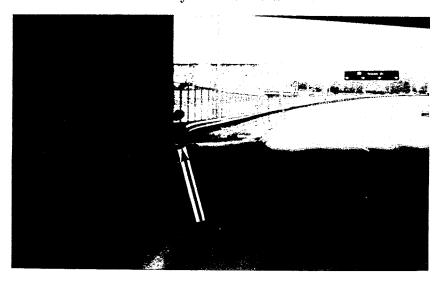
To provide a sliding action, that rail should have been behind the wall instead of the end sticking out. These are just plain wrong and are going to chop up cars for no good reason at all. The material is there to do the right job.

I want to say again, 90 percent of the stuff I am showing you has nothing to do with money at all. It costs less money to do it, so it has nothing to do with money, and that is an important point. This should be behind the wall so you cannot hit it.

This should be behind the wall. These are designed to stop you. Not only do you damage your car, you damage the rail, and we have to pay, pay—for no good reason at all. Next I have a series of slides on rail ends.
